OCTOBER 26, 2023
Architectural Project #2214
REA PARK CLUBHOUSE
RENOVATION & ADDITIONS

ADDENDUM NO. 2

PROJECT: Rea Park Clubhouse Renovation and Additions
The City of Terre Haute – Board of Public Works

S2.0

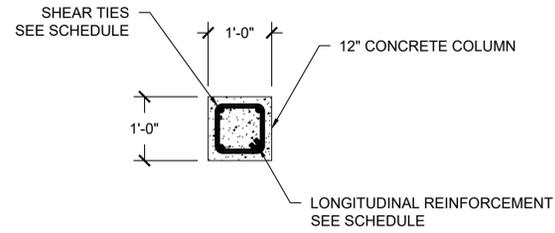
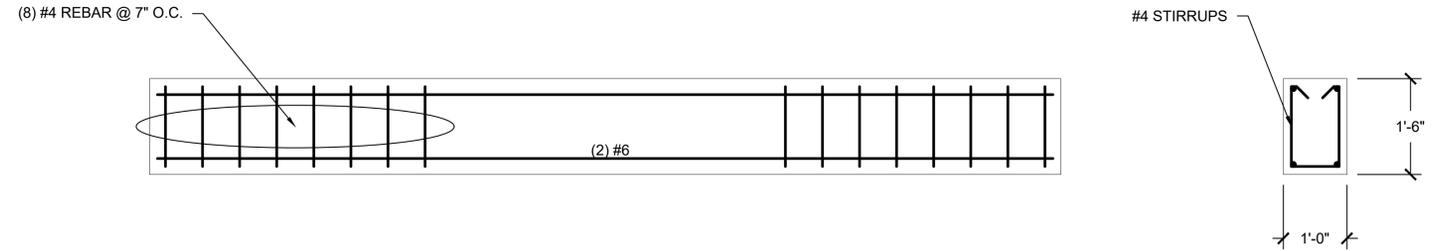
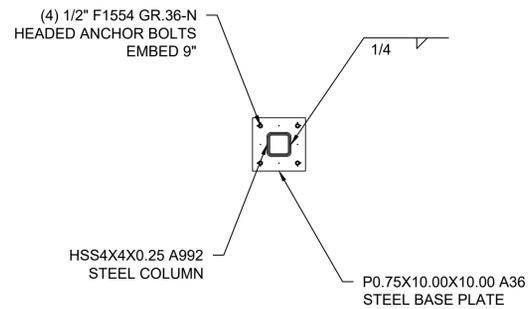
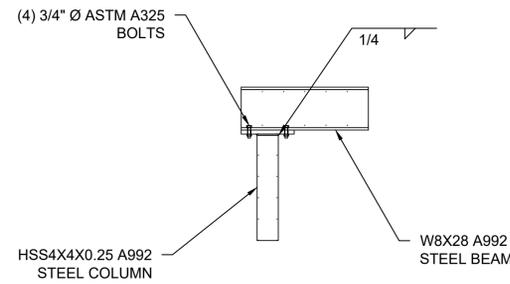
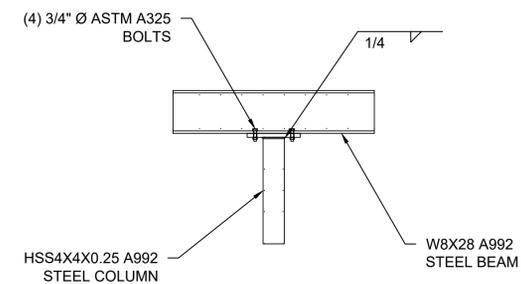
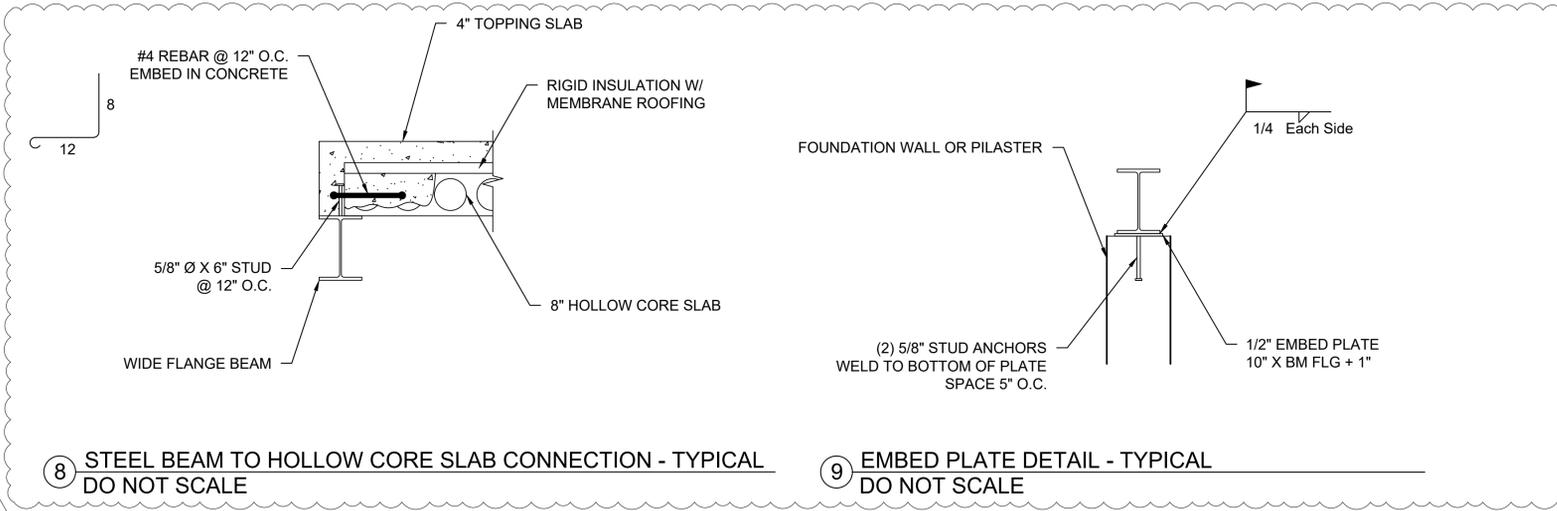
- Item #1 Revised structural schedules and additional structural details have been added to Sheet S2.0. Structural notes have been moved to Sheet F2.0. (See revised **Sheets F2.0 And S2.0**)

BASEMENT PLUMBING PLAN
 SCALE 1/8" = 1'-0"
 NORTH

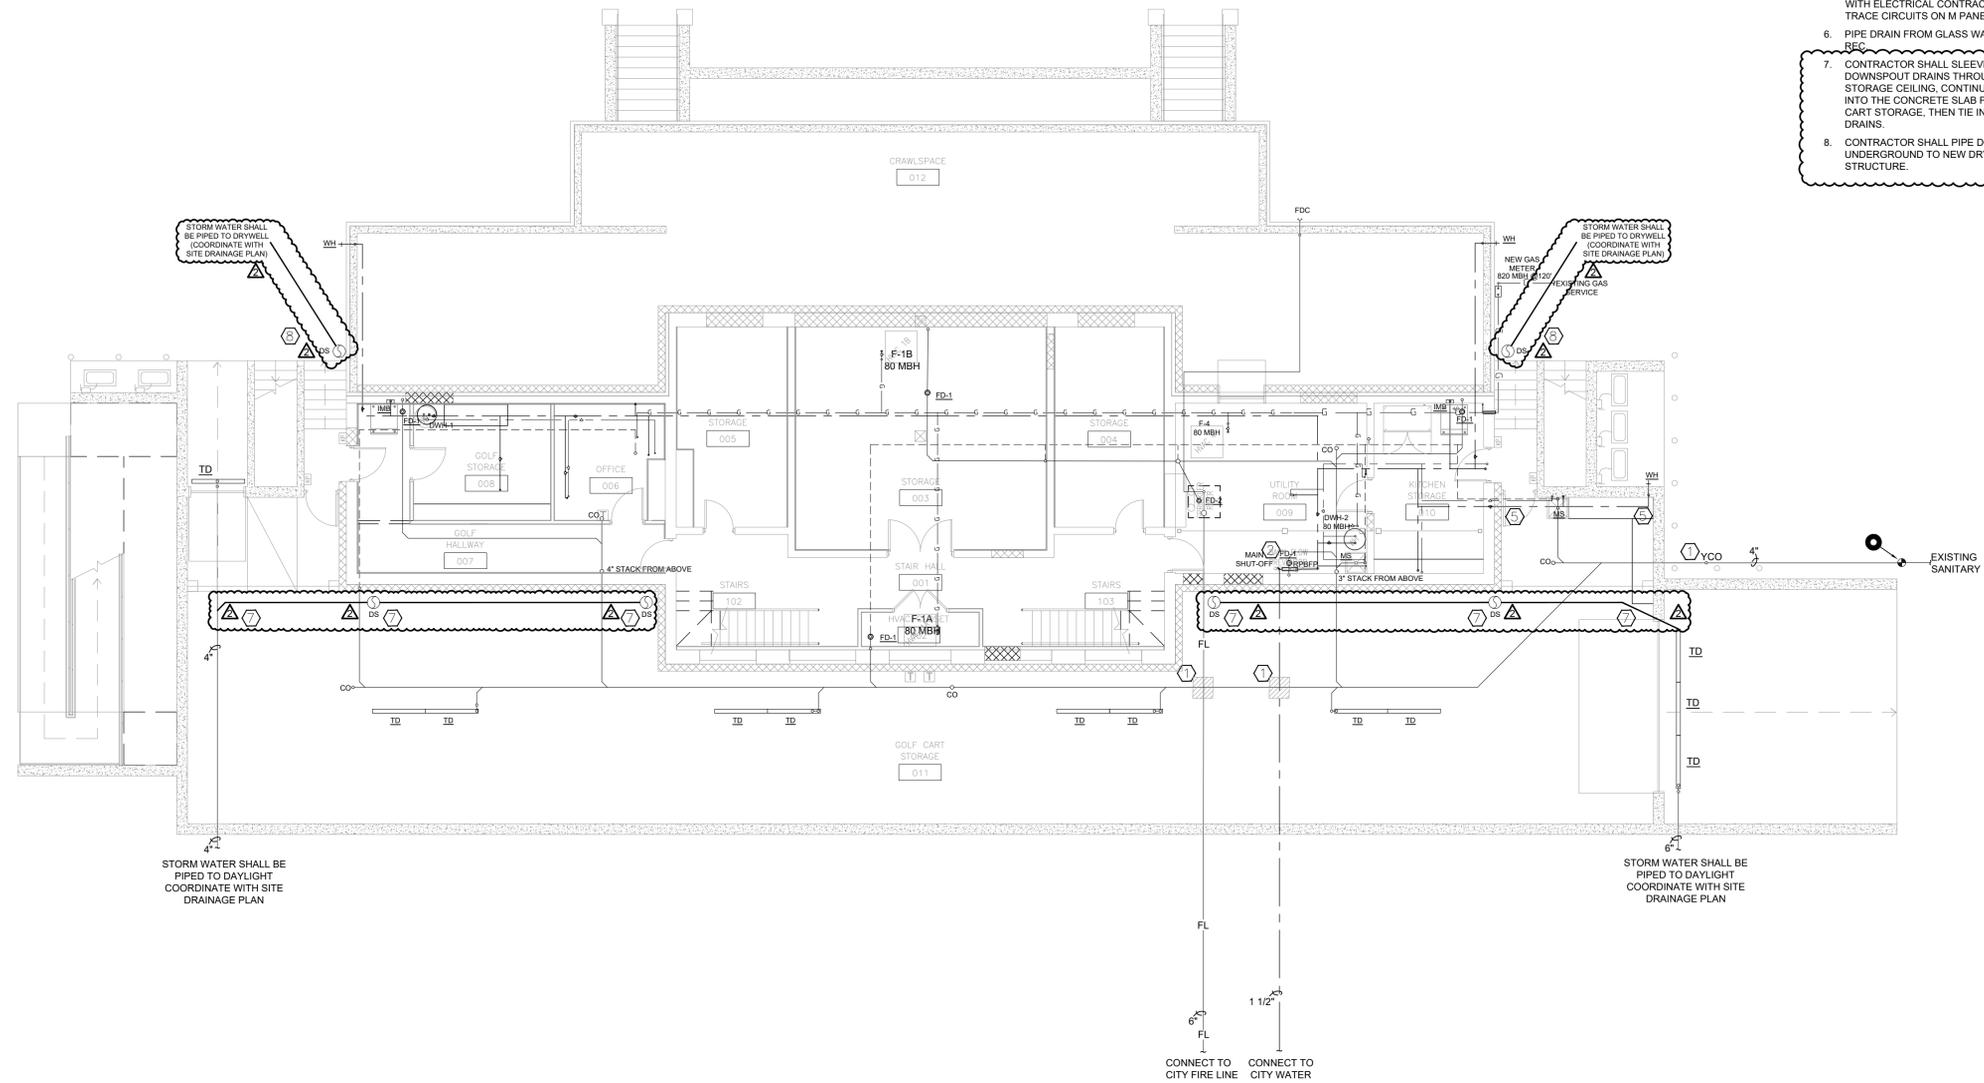
- Item #12 Downspout drainage has been added to the Basement Plumbing Plan. (See revised **Sheets P0.1 and P1.1**)
- Item #13 Contractor is responsible for all temporary shoring, bracing and other temporary construction necessary to ensure that the structural integrity of the existing structure is maintained during construction activities. Note has been added to Demolition Sheets. (See revised **Sheets D-0 thru D-4**)
